SAFETY RECALL

MACK Trucks Inc.
Greensboro, NC USA

Date	Number	Release	Page
07.2016	SC0404	01	1 (11)

Meritor Steer Axle, Replacement

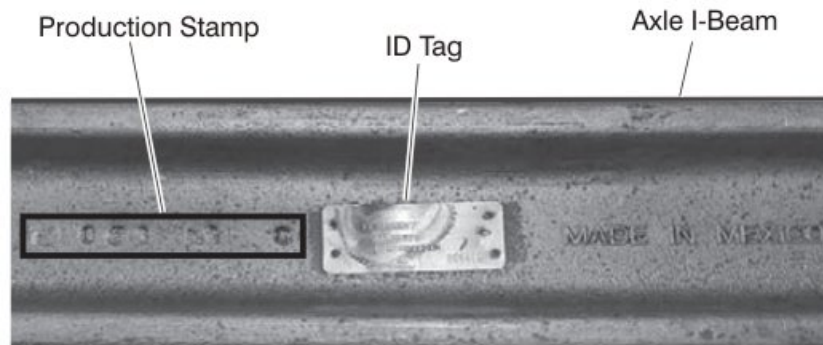
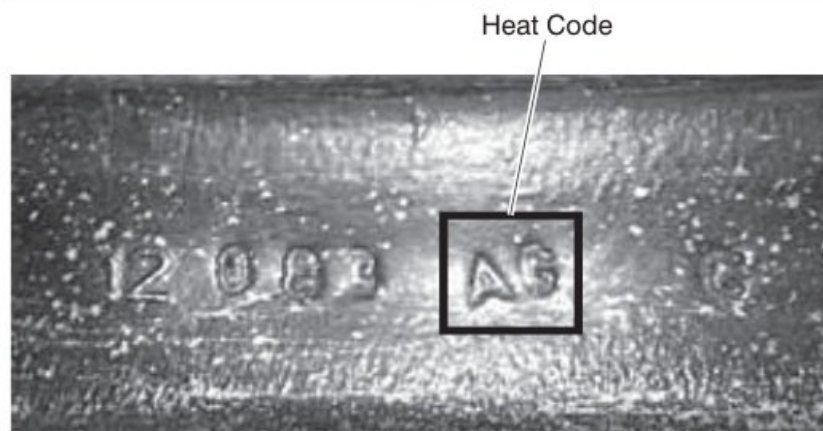
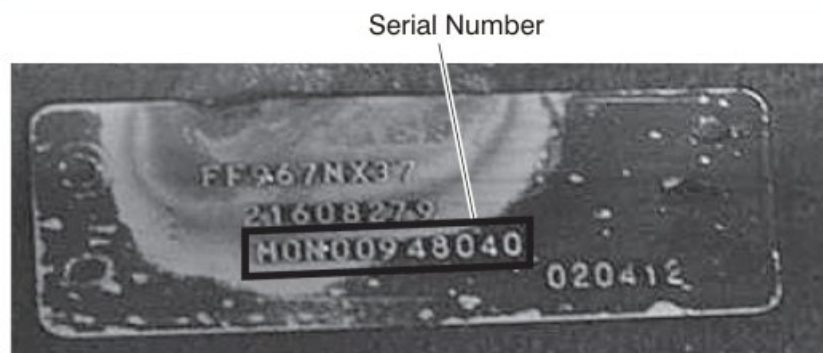
1. Find and record the heat code stamped on the axle and the axle serial number located on the identification tag at the front/center of the steer axle. See Figures 1, 2, and 3.

2. Ensure the heat code is “**AG**”, as shown in Figure 2.
3. Check the axle serial number against the list on page 5 (Figure 4) of this safety recall.

If both the heat code is “AG” and the axle serial number is on the list, the axle will require replacement according to the replacement procedures in this safety recall. Before you begin service, contact the Meritor OnTrac™ Customer Call Center at 866-668-7221 or email the center at ontrac@meritor.com. Use the pre-call worksheet on page 10 of this safety recall to collect required information. OnTrac will create a case number and send you the kit required for service.

If either the heat code is NOT “AG” or the axle serial number is NOT on the list, follow the OEM’s program guidance to close out the program warranty claim. Record the heat code and axle serial number in the OEM claim comments. Return the vehicle to the owner.
